FCO CA06199: Mean Well Power Supply PS3

Document number: 719-00502A-B

Trendsetter® NEWS 200

Figure 3: Connecting 10-4850 to modified Mean Well PS3 connections

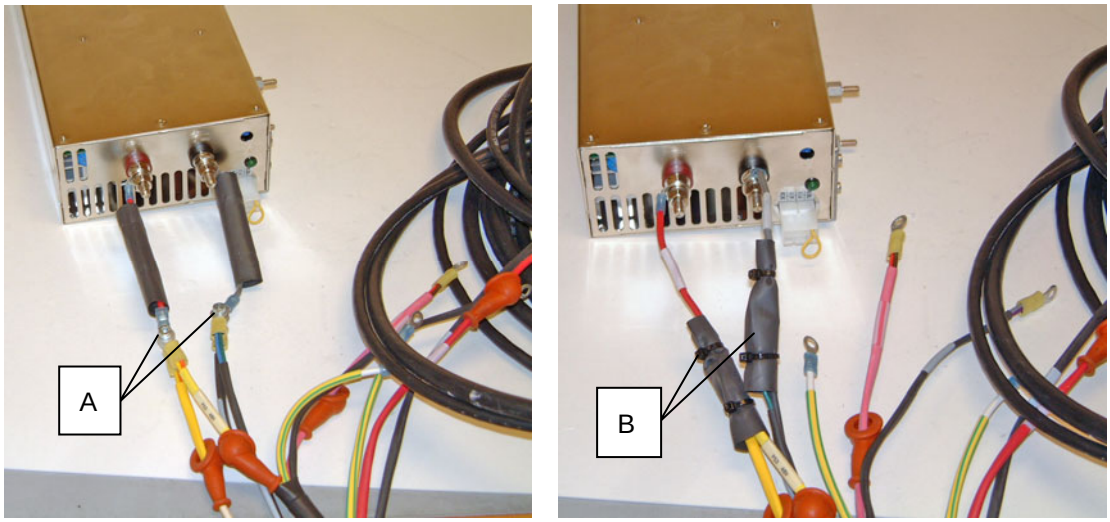
7. Connect thermal imaging head power cable 10-4850A to the short adapter cables on the new Mean Well PS3, using a screw, nut, and star-washer (see A in Figure 3).

8. Cover the connections between cable 10-4850A and the short adapter cables on power supply PS4 with heat-shrink tubing. Use cable ties to secure the heat shrink tubing to each connection (see B in Figure 3).
